Our Ref: 150316 Hotel

SICEEP - Hotel Porte Cochere

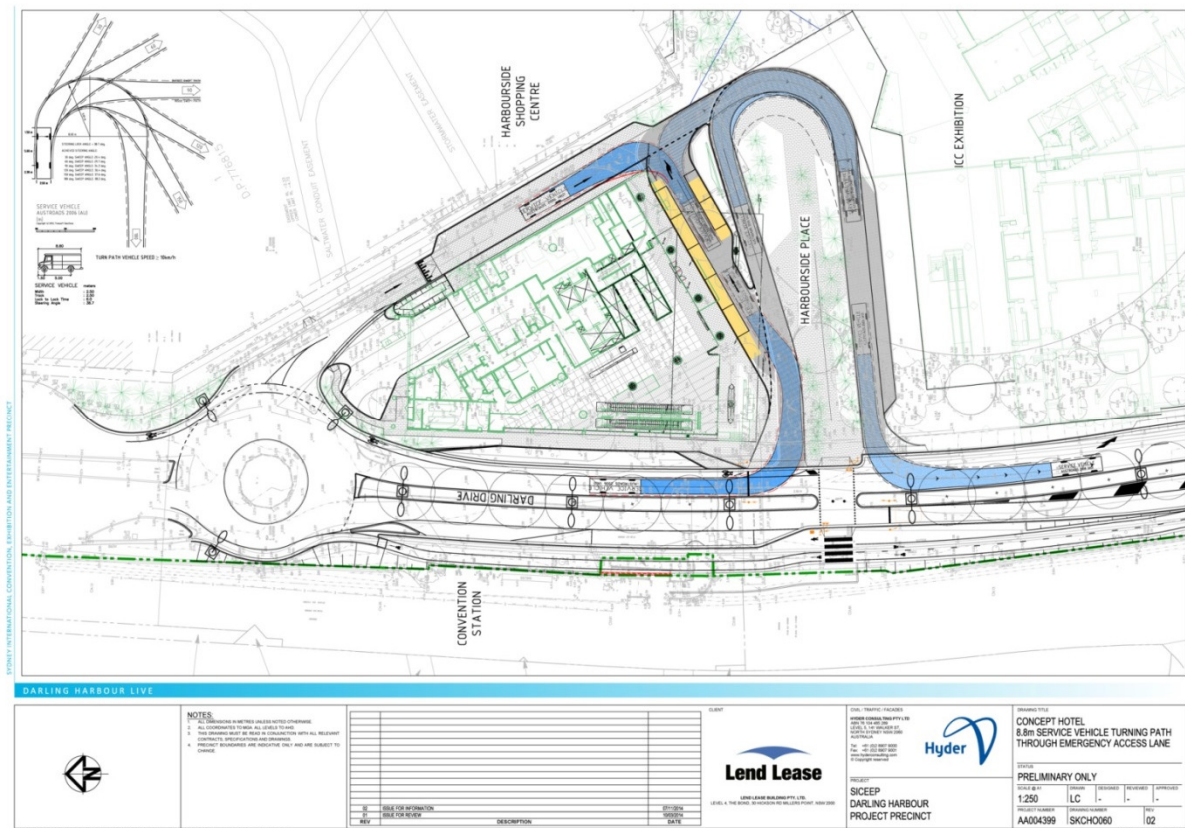
The below sketch plan responds to this request, as was provided in our email dated 7th November 2014 showing the turning path for an Austroads 8.8m Service Vehicle using the Autoturn add on software for AutoCAD. This demonstrates that the revised Porte Cochere car parking layout does not affect service vehicle turning paths through this area

We have reviewed the revised Porte Cochere car parking layout and note that it does not affect service vehicle turning paths through this area.

The revised Porte Cochere parking layout provides an additional parking bay. The provision of this additional parking bay does not affect the assumptions and findings of the previous DA report.
